# AN APPLICATION OF THE SAFE SYSTEM APPROACH TO INTERSECTIONS IN THE CAPITAL REGION – PILOT PROJECT

## TASK 6 – WORKSHOP TASK 7 – ROAD SAFETY AUDITING

Report to  
Capital Region Intersection Safety Partnership (CRISP)

Figure 1. Squirrel intersection schematic.

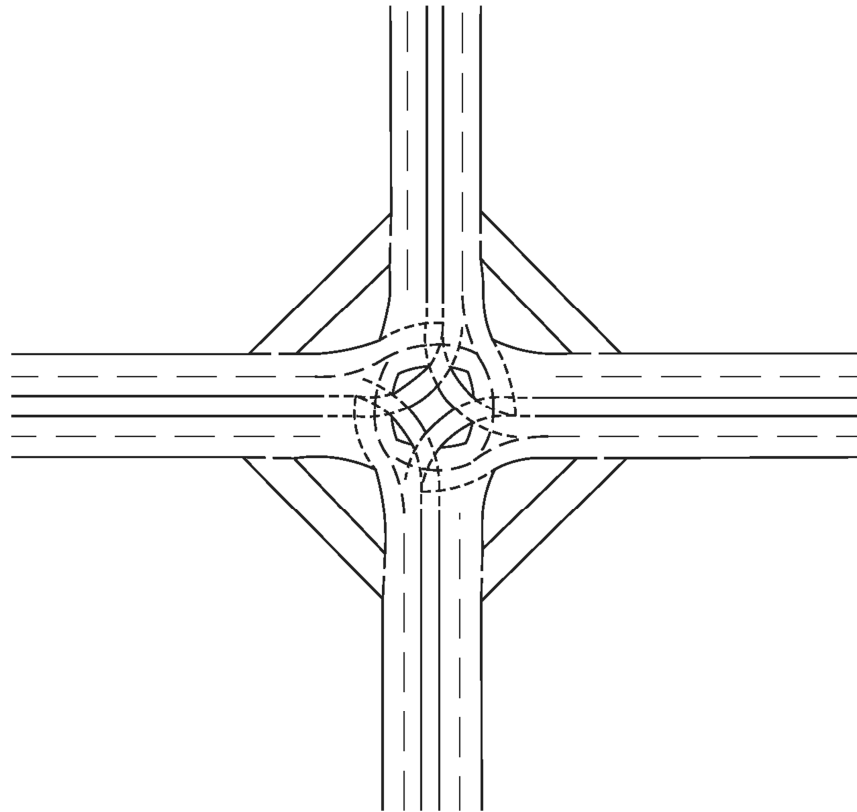
*Reduced collision speeds, favourable impact angles*

*Capacity issues*

*Potential to cause driver confusion*

*Winter maintenance*

Individuals seemed impressed with this design as a generic engineering solution to a generic problem but were hesitant to consider it for the intersections in discussion. It should be noted that the original design concept was intended for undivided roads intersecting under existing traffic signal control. Thus, the potential for the squirrel to apply at the intersection of divided roads is limited; for divided roadway cases, the Cut-through design was developed specifically.

At St Albert Trail and Villeneuve, St Albert, participants saw some benefits in the squircle, particularly with regard to its compact layout and lower speeds. Similar views were held for 94 Ave and 91 St, Edmonton and Baseline Road and Broadmoor Boulevard in Strathcona County.

While most groups acknowledged that the squircle would, in principle, reduce collision speeds and promote more favourable impact angles, and potentially reduce the number of collisions, individuals expressed concerns about capacity and volume. There were also several comments made regarding the potential for the squircle (at the intersections being considered) to cause driver confusion due to its unconventional nature. It was also noted that from a practical point of view that winter maintenance of a squircle may be difficult.

It was noticeable that when suggesting improvements to the squircle (to make the design more acceptable), that the design concerns were those which could be overcome if the squircle was engineered specifically for the above locations, i.e., increasing the number of lanes, providing better signage to warn of changed traffic conditions, changing signal timings.

*Figure 2. Cut-through intersection schematic.*

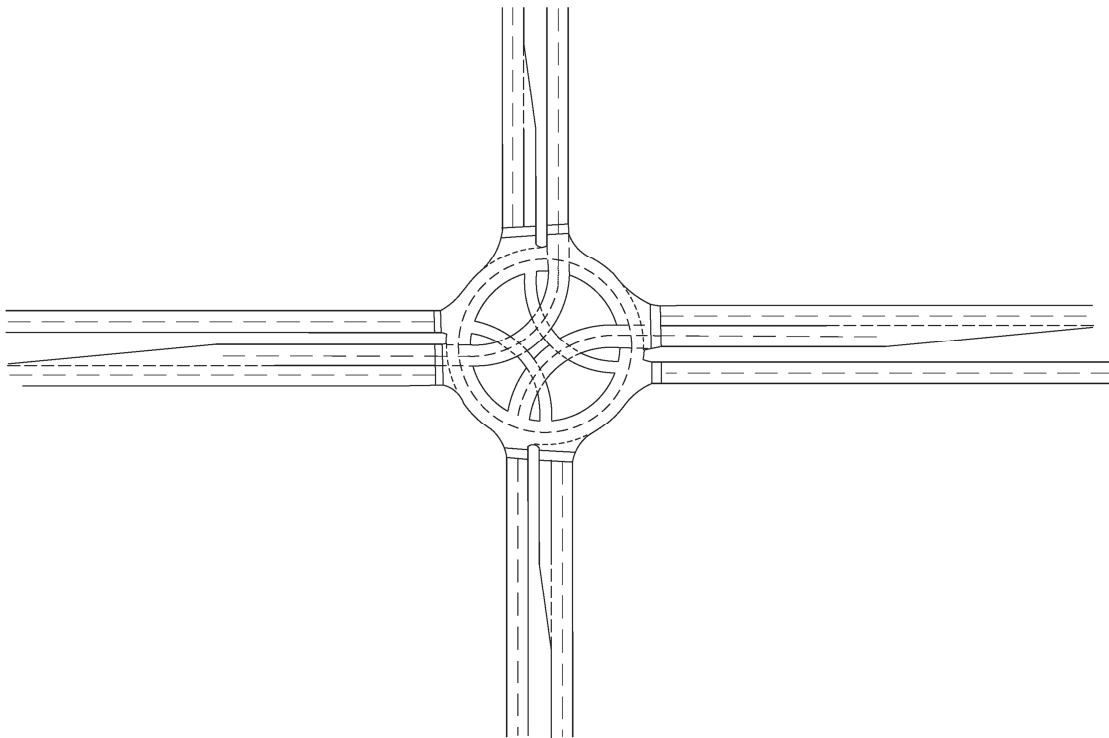
*Less complicated than existing intersections*

*Reduce incidence of right angle and left turn across path collisions*

*Accommodation of heavy vehicles*

*Signal timing issues*

This intersection design was well-received because it appeared to the groups to be more suited (in terms of its size) for application to the subject intersections. As noted in Section 2.1 (squirrel) above, the Cut-through was designed to suit divided road, signalised intersections, while the squirrel was intended for undivided signalised intersections. Two groups had noted that it 'fits in' immediately. It was also noted that this design was less complicated and would most likely reduce right angle and left turn across path collisions, such as a side-angle collision occurring between two vehicles using a channelised right-turning bay. It was also noted that it reduces conflict speeds, the number of conflict points and improves entry angles.

The cut-through design seemed to be favoured more for the Baseline and Broadmoor site, for Wye Road and Sherwood Drive, Strathcona County and for St Albert Trail and Villeneuve Road.

The problems identified in the workshop were primarily operational in nature, relating to the difficulties trucks might find in manoeuvring through the Cut-through intersections, as well as signal timing issues. It was noted specifically that at 107 Ave and 142 St in the City of Edmonton, the Cut-through was thought to be unlikely to fix the problem that currently existed at the intersection, involving a large number of – relatively minor – collisions on the approach to and within the existing traffic circle due to a number of factors including its large size causing higher speeds, poor pedestrian sightlines and weaving within the circle. The improvements suggested were in relation to signalling the intersection and in all cases, paying extra attention to the needs of the right-turn/left-turn lanes since this was mentioned at four of the five intersections discussed. It is worth noting that, despite its perceived disadvantages, the cut-through would still be more favourable than a conventional signalised four-leg intersection due to reduced collision speeds and more oblique impact angles. Minor collision incidence may not be influenced positively, but serious and fatal collisions should be significantly reduced.

Figure 3. Quadrant Roadway intersection schematic.

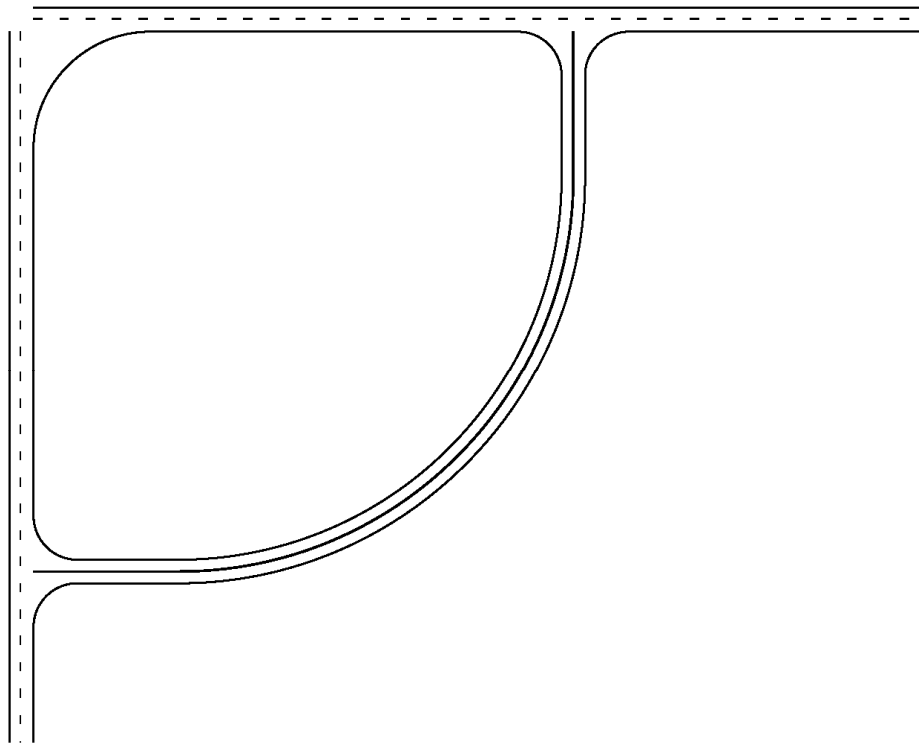
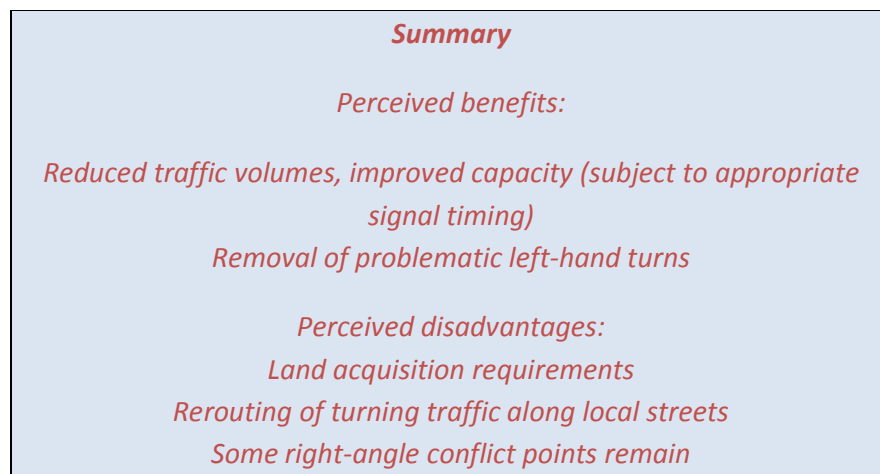
This intersection design was discussed with some reservations by groups considering it as a replacement intersection at the following sites:

Those discussing the St Albert Tr and St Anne Street intersection regarded it as not feasible for this location, most likely due to the land acquisition required. Discussions regarding the Quadrant Roadway design at two intersections in Strathcona County (Baseline and Broadmoor and Wye and Sherwood) were more positive, with the groups seeing benefits of this design particularly in terms of reducing volumes and improving capacity at the site, in addition to removing problematic left-hand turns. Both groups noted surmountable obstacles with the Quadrant Roadway such as signal timing and capacity issues, but noted the potential for left-turn and right-angle collisions at Wye and Sherwood to remain, as well as the possibility of the need to acquire considerable additional land to accommodate the design. Concern was also expressed at the undesirability of re-routing turning traffic along neighbourhood streets.

Figure 5. Turbo Roundabout schematic.

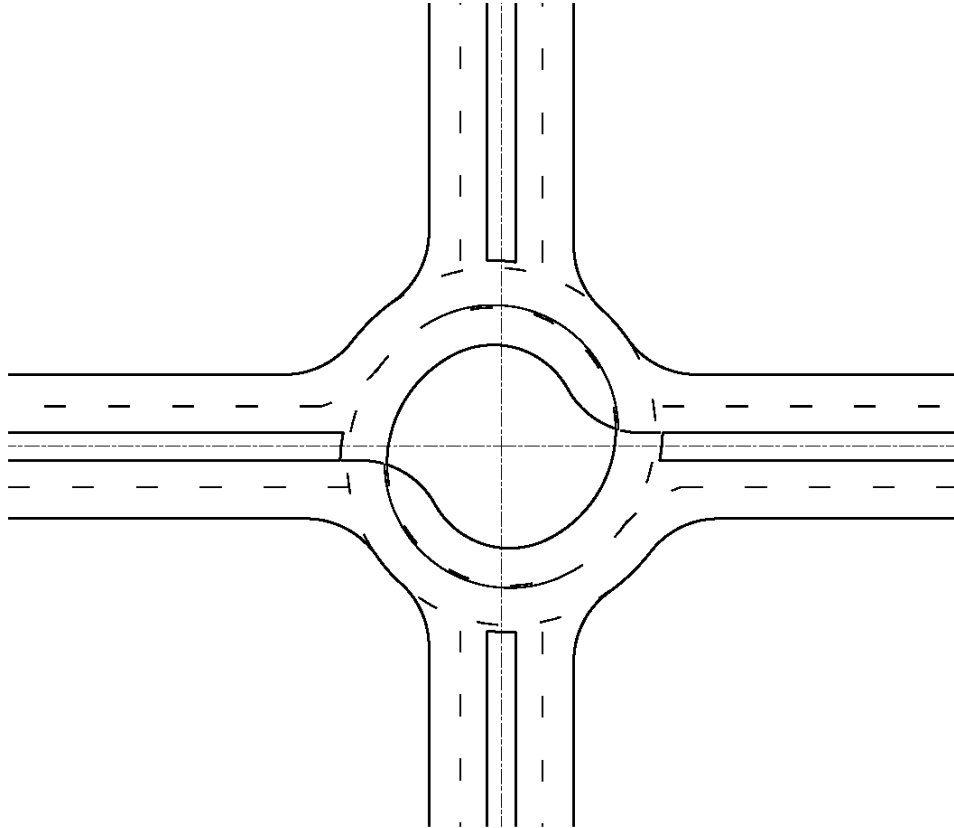
*Improved conflict angles*

*Capacity limitations*

*Winter maintenance*

*Accommodation for cyclists and pedestrians*

The turbo-roundabout was viewed favourably as a potential Safe System solution for all intersections discussed, with groups highlighting its ability to reduce collision speeds and angles, and making note of its ability to use land space efficiently. It was, however, noted that the turbo roundabout may not be able to address capacity issues at each site, and on a more practical note, could not be used as an engineering solution at 107 Ave and 142 St due to the site being part of the Groat/107/142 'race track', although it should be noted that the turbo design is specifically targeted at reducing entry speeds to well below 50 km/h. Concern was also raised regarding winter maintenance, and

accommodating bicycle and pedestrian movements if the turbo roundabout was installed at Wye and Sherwood. As with the squircle, the concerns were felt to be more able to be addressed during early phases of design if the turbo roundabout was to be used at any of the sites. Workshop participants had a number of ideas for improving the turbo design, all of which appear achievable, including allowing for 'double movements', retaining right-turn slip lanes to maintain intersection capacity, and either installing rumble strips or raised lane dividers to address winter maintenance concerns. It was also suggested that the turbo roundabout could be signalised, if required, to improve intersection operation.

Figure 6. Roundabout schematic.

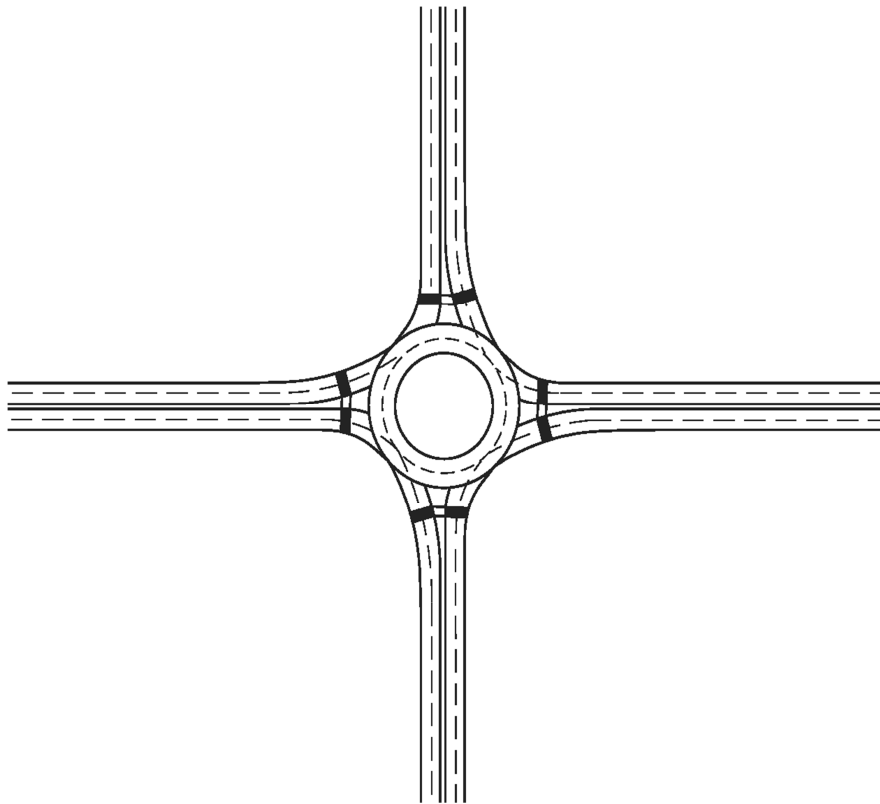
*Elimination of right-angle impacts*

*Capacity issues*

*Accommodation for heavy vehicles*

Like the turbo roundabout, the traditional roundabout was also well received by each of the groups as a potential solution to each of the intersections discussed. Groups acknowledged the ability of the roundabout to eliminate right-angle impacts, reduce collision speeds and improve collision angles while meeting 'driver expectations', most likely because roundabouts and traffic circles are relatively well-known compared with the more innovative designs considered. It was considered preferable to the turbo roundabout at St Albert Trail and Villeneuve Road and also considered for 107 Ave and 142 St as well as 34 Ave and 91 St, Edmonton. At the Baseline and Broadmoor, and Wye and Sherwood locations, signalised feeder lanes were thought an option for making the roundabout practical at these sites. However, all groups did note that addressing capacity issues is important and further stated that accommodating pedestrians, trucks and buses might be a challenge (at three separate intersections). Given that these issues are likely to be able to be accommodated during the design phase in the generic case, it was considered likely that roundabouts would be well received and yield promising results at each of the subject intersections. While participants provided specifics regarding how the roundabout could be engineered to fit 107 Ave and 142 St Edmonton, general improvement suggestions made for the other intersections included the insertion of raised cross-walks, geometry adjustments and signalised feeder lanes to overcome potential operational problems during peak periods. Overall, the roundabout, as with the turbo roundabout, appeared to be more readily accepted with most participants' concerns and general issues able to be addressed.

*Figure 7. Baseline & Broadmoor, Strathcona County.*

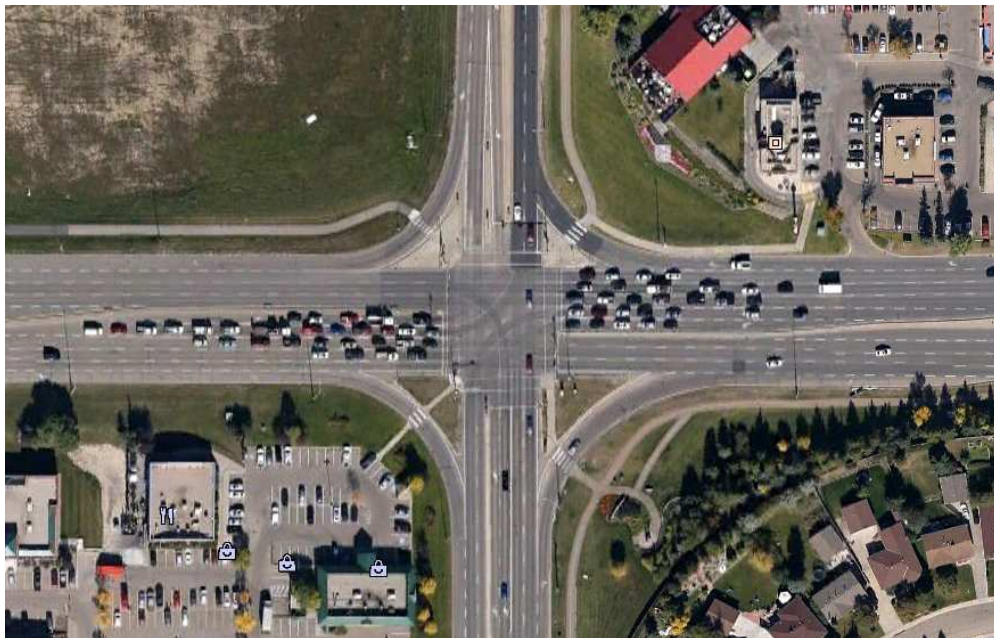
As a fairly large, multi-lane intersection, the cut-through intersection design is probably the preferred Safe System solution for this location, although workshop participants flagged this site as a candidate for grade separation or a full interchange.
